#### **NORTH ANNA EARLY SITE PERMIT APPLICATION**

**DOMINION NUCLEAR NORTH ANNA, LLC**  
**NORTH ANNA EARLY SITE PERMIT APPLICATION**  
**RESPONSE TO NRC QUESTIONS AND REVISION 6 TO THE NORTH ANNA ESP**  
**APPLICATION**

**Enclosure 1**  
**Dominion Response to March 2 and**  
**March 13, 2006 NRC Questions**

### **Correction of Coordinates for ESP Site Footprint**

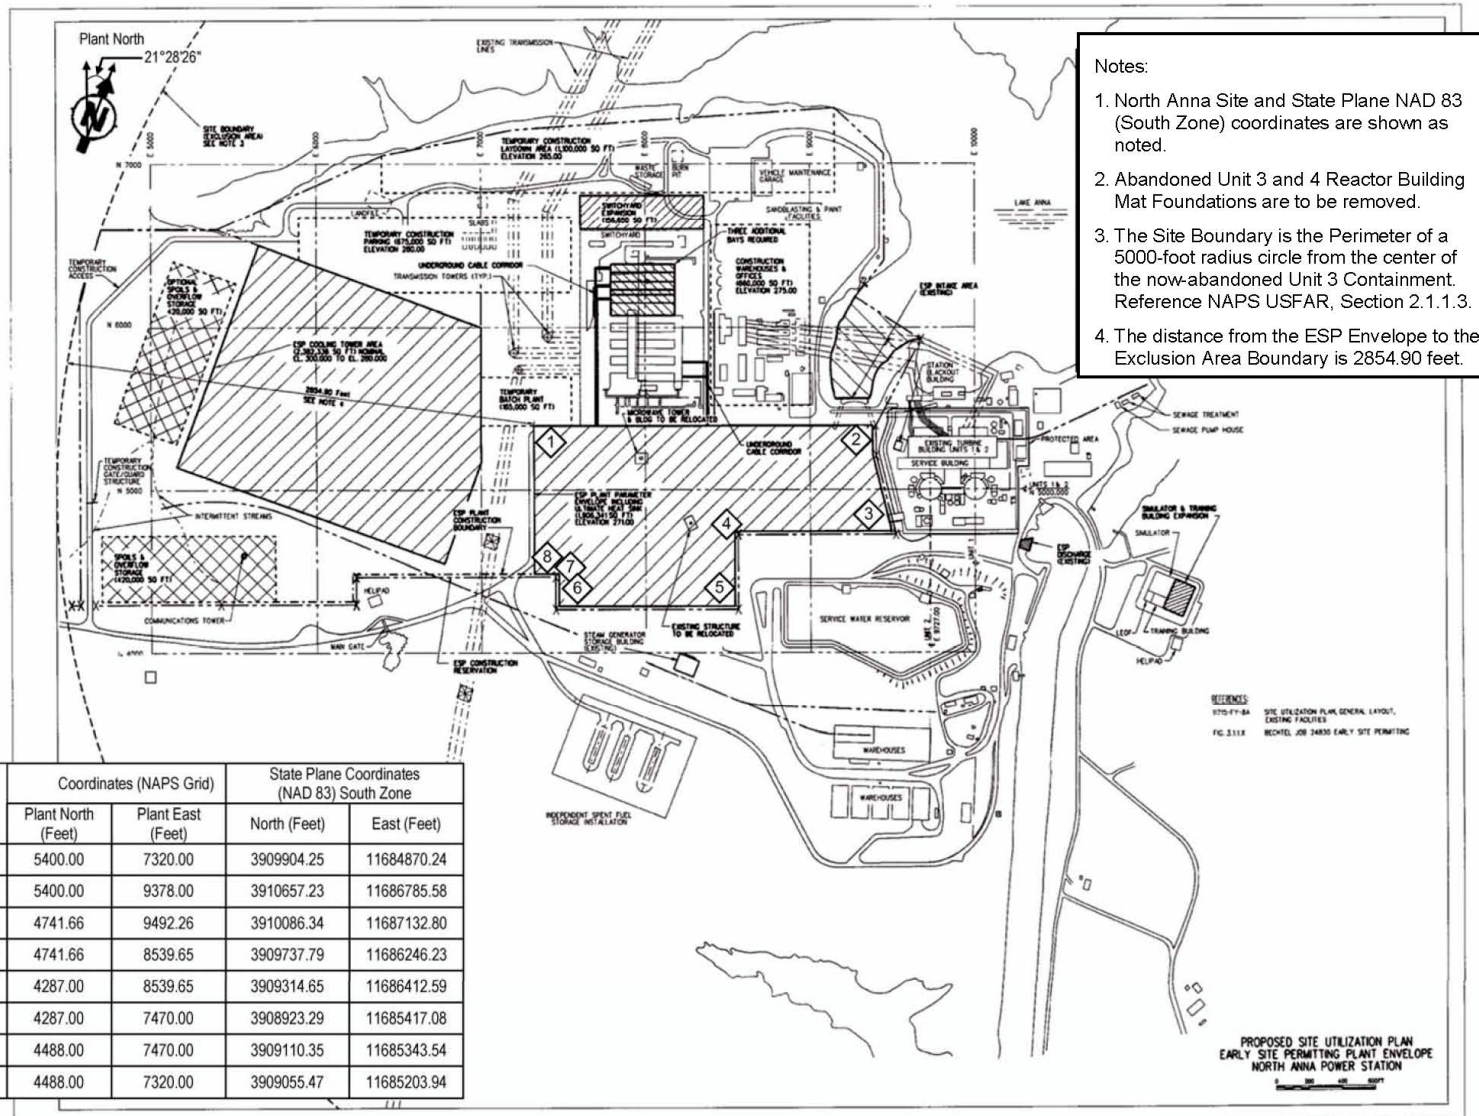
Coordinates for the ESP site footprint were submitted to the NRC in response to Draft Safety Evaluation Report (DSER) Open Item 2.4-1 (Dominion Letter 05-785B dated March 3, 2005).

As discussed in a July 5, 2005 conference call with NRC Staff, upon further review, it has been determined that the coordinates identified in Figure 1 of the DSER Open Item 2.4-1 response contained errors.

A corrected version of Figure 1 is provided on the next page.

Figure 2.5-55A

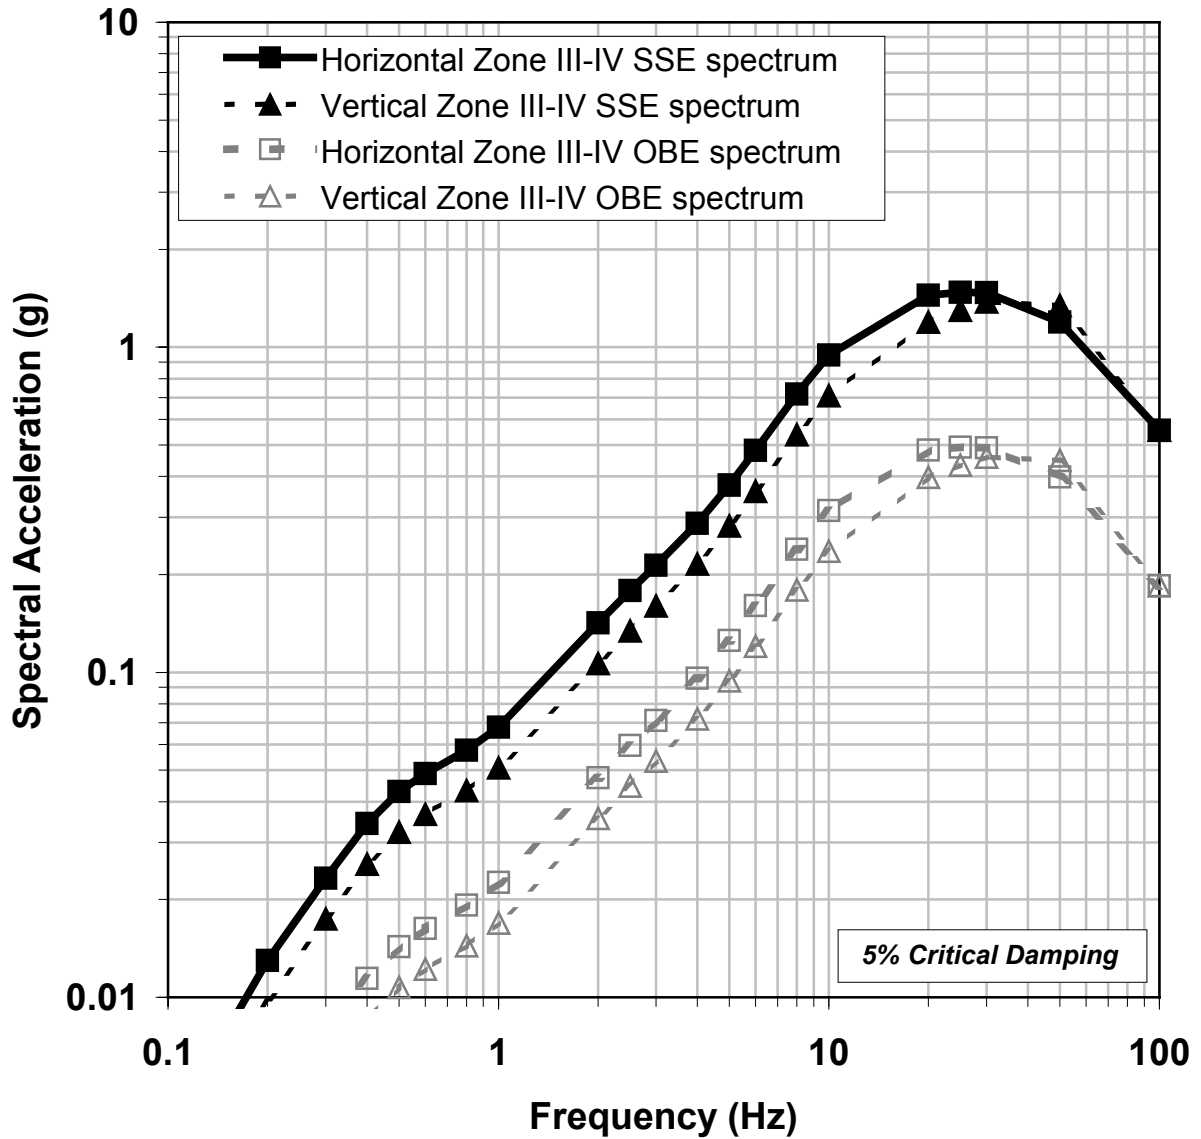
In Dominion's response to DSER Open Item 2.5-2 (Dominion Letter 05-194 dated March 30, 2005), a new SSAR figure, Figure 2.5-55A, was included titled:

Revision 4 of the North Anna ESP Application included an incorrect version of SSAR Figure 2.5-55A. (A duplicate copy of SSAR Figure 2.5-55 was inadvertently included as SSAR Figure 2.5-55A.)

The correct version of SSAR Figure 2.5-55A has been incorporated in Revision 5 of the ESP Application.

In Revision 5 of the ESP Application, SSAR Figure 2.5-55A has been replaced with the correct version shown on the next page.

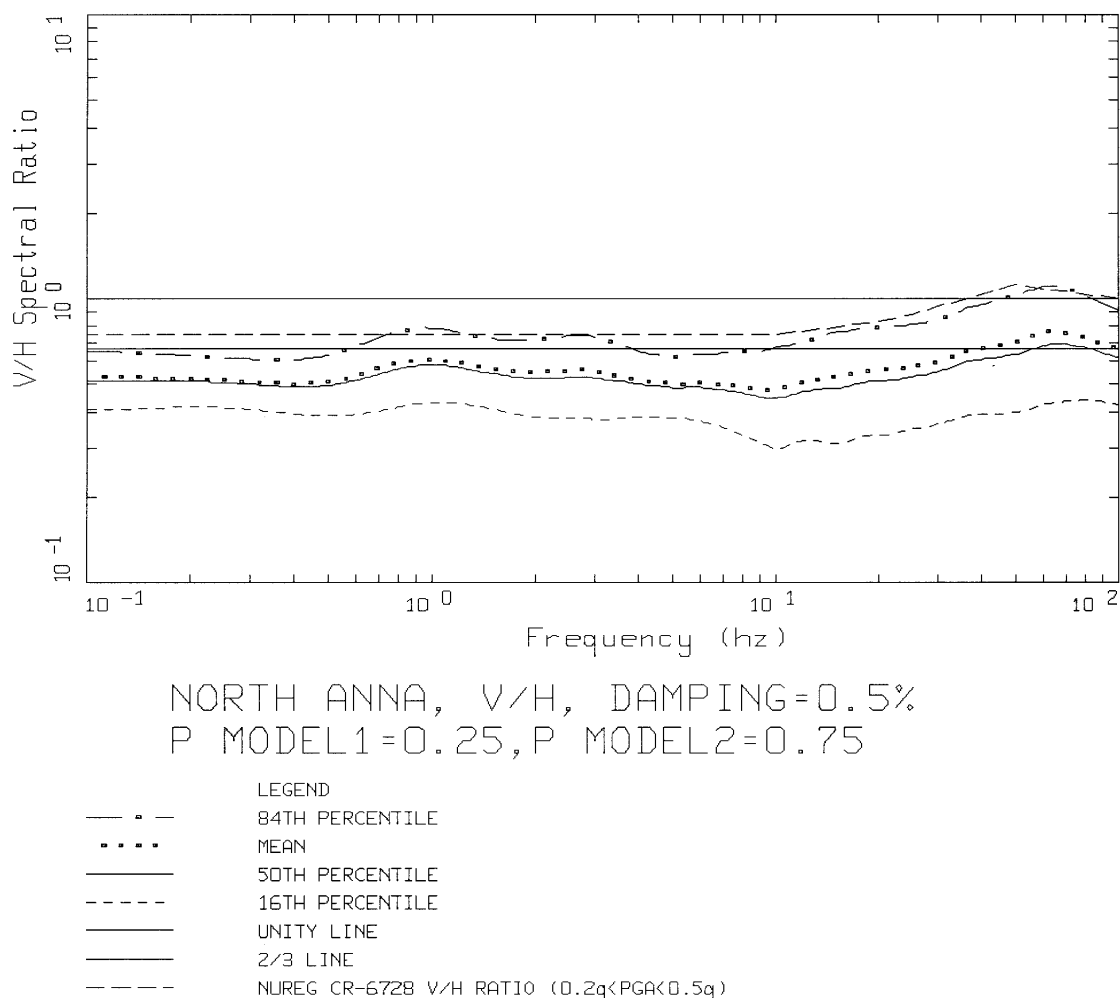
The statistical results of the V/H spectral ratios for the 0.5% damping level are shown in Figure 2. For comparison purposes, the V/H ratio for the 0.2g<PGA<0.5g bin from NUREG/CR-6728, which was used in SSAR Table 2.5-27A, is shown in Figure 2.

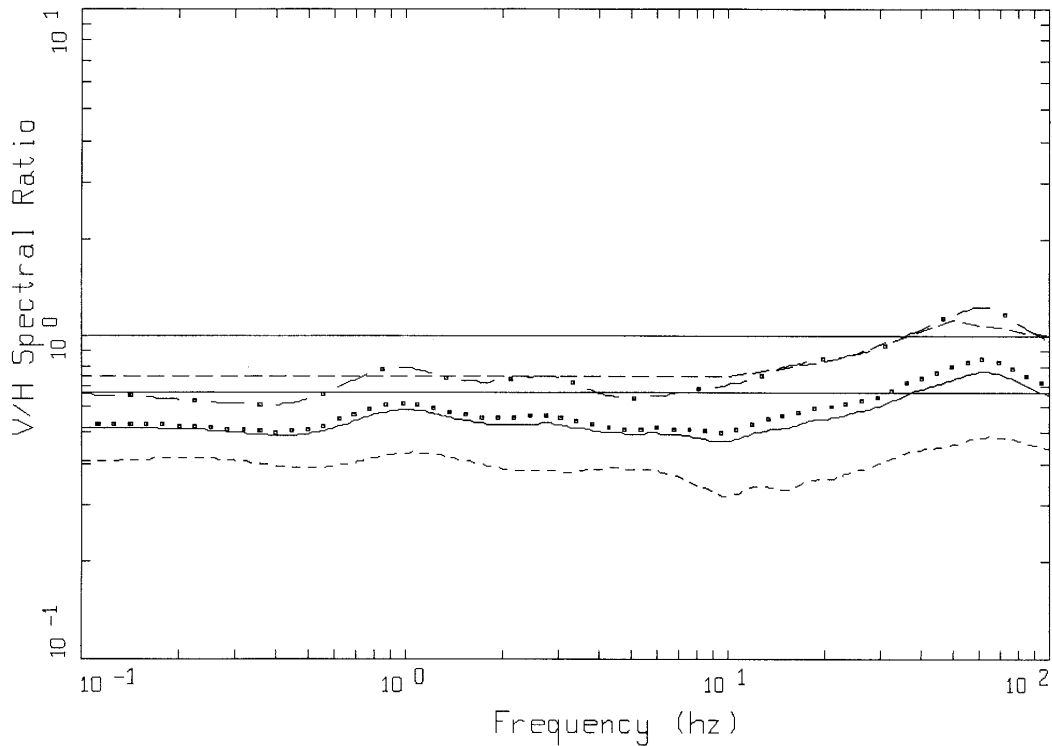
The 16<sup>th</sup>, 50<sup>th</sup>, and 84<sup>th</sup> percentiles and mean V/H ratios are shown in Figure 4 for the 2.0% damping case and listed in Table 2. For comparison, the V/H ratios from NUREG/CR-6728 for the 0.2g<PGA<0.5g case, which was used for SSAR Table 2.5-27A, are also shown in Figure 4 and listed in Table 2. On average, the mean V/H ratios from the site-specific analysis are approximately 30% lower (ranging from 18-35% lower) over the complete frequency range of 100 Hz to 0.1 Hz than the V/H ratios used in SSAR Table 2.5-27A. At the 84<sup>th</sup> percentile, the site-specific V/H ratio values are on average 8% lower (ranging from 19% lower to 5% higher) over the entire frequency range than the SSAR Table 2.5-27A V/H ratio values.

The site-specific analysis included the deaggregation information from the high frequency (i.e., 5-10 Hz) controlling earthquake only. If a more detailed analysis were performed, the deaggregation events from the low-frequency (i.e., 1-2.5 Hz) deaggregation would be included. In addition, the 5-10 Hz deaggregation events for distances greater than 75 km were included in the 75 km case. These factors would lead to a more conservative V/H ratio (shown in Figure 4) for the lower frequency range than for the higher frequency range.

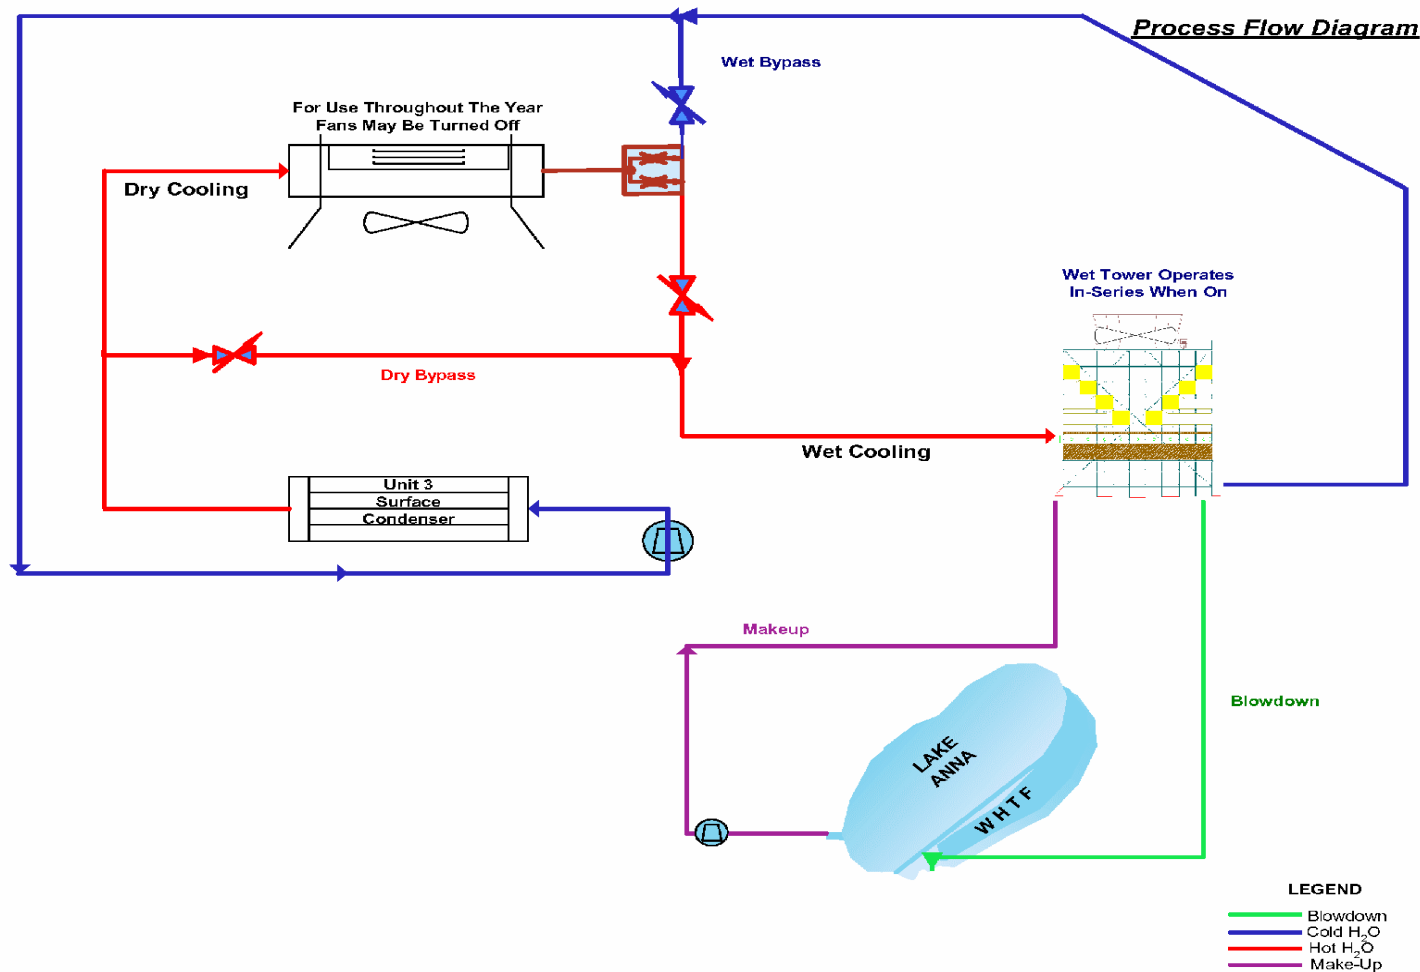
The normal plant cooling system is a closed cycle system combining dry and wet cooling towers to provide the capability to reduce water consumption during drought conditions. The process flow diagram for the system is shown in the attached Figure. In the Maximum Water Conservation (MWC) mode of operation, heated cooling water leaving the plant main condenser would be cooled in a dry cooling tower section where a minimum of one-third of the heat would be rejected. The cooling water passes through the tubes of the dry cooler while fans move air across the outside of the tubes to transfer the heat to the air. After passing through the dry coolers, the water then passes through a wet cooling tower section, where the remaining heat is dissipated by spraying the water into an air stream, achieving the majority of the heat transfer by evaporation of a portion of the water. The cooled water then returns to the plant condenser to condense the steam leaving the turbines. When the system is in the Energy Conservation (EC) mode of operation, the dry tower fans are turned off with 100% of the cooling then provided using the wet tower section.

Several features are available for conserving water in wet cooling towers. A hybrid tower can be used that incorporates a dry cooling section into the top of the wet cooling tower. A portion of the water entering the tower passes through the tube side of a heat exchanger while air is drawn or forced over the tubes before mixing with the air that has passed through the wet section. This configuration increases the heat transfer due to convection and conduction and reduces the amount of evaporation required to achieve the desired return temperature to the condenser.

A variation of the hybrid tower uses a dry section above the wet tower section where cooler outside air is drawn in through ducts while the warm moist air from the wet section exhaust passes over the outside of the ducts. Water from the wet section exhaust condenses on the cooler dry section duct surfaces and falls back into the process stream before leaving the cooling tower, thereby reducing the water loss due to evaporation.

ER Section 3.4.1.1 is revised to include the diagram of the cooling system shown in the attached Figure and to describe examples of the water saving features that could be used in the wet towers. The figure in the ER Section also includes a plant service water system described in the section.

**Figure 1: Flow Reduction ( $\Delta Q = Q_2 - Q_3$ ) over Dam (from October 1978 to April 2003)**

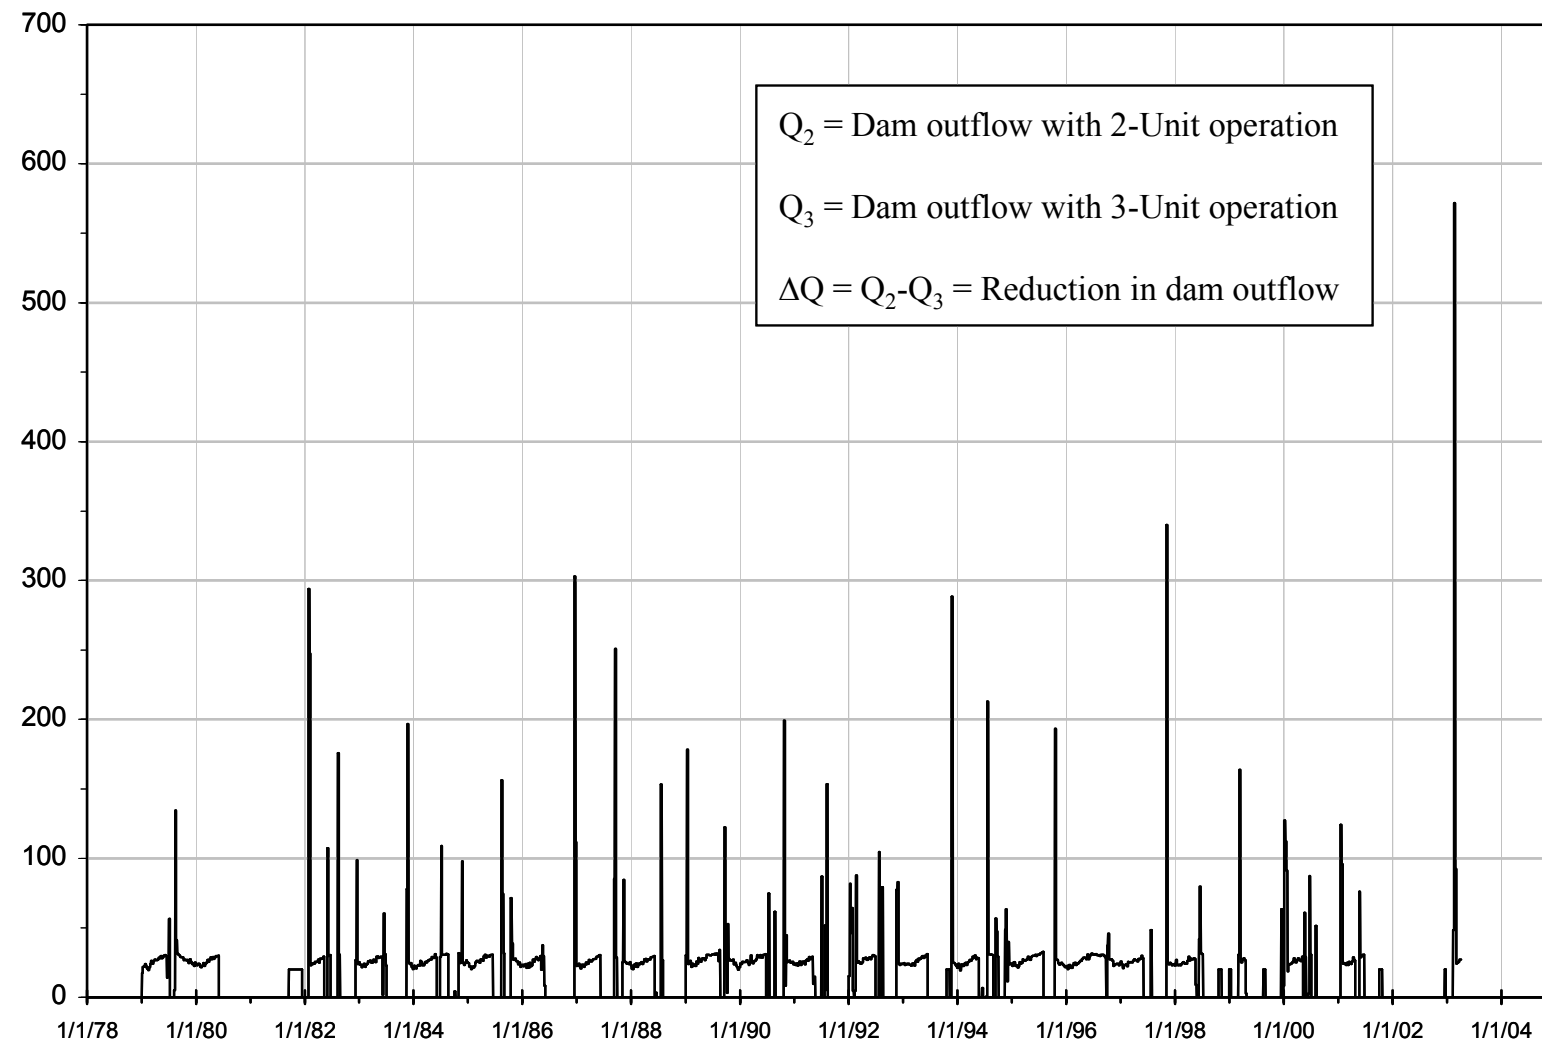
Certain characteristics of the changes in flow at the dam between 2-unit and 3-unit operation are apparent from these calculations as illustrated in Figure 1:

- There are short periods with a difference of 20 cfs, e.g., when 2-unit operation is releasing 40 cfs minimum flow, but 3-unit operation, with a lower lake level, would release 20 cfs, which would have occurred seven times in the 1978-to-2003 period, lasting one week to 3 months;

- There are periods when the 2-unit dam release is much larger (up to 550 cfs, but mostly 100 to 350 cfs) than the 3-unit release, due to the fact that runoff after a dry period fills the reservoir level to elevation 250 ft more rapidly for the 2-unit case and nearly all the river inflow is passed over the dam for a short period before the reservoir would have filled under the 3-unit scenario. Flow differences above 100 cfs would have occurred approximately 25 times in the 1978-to-2003 period, with each episode lasting a few days to two weeks.
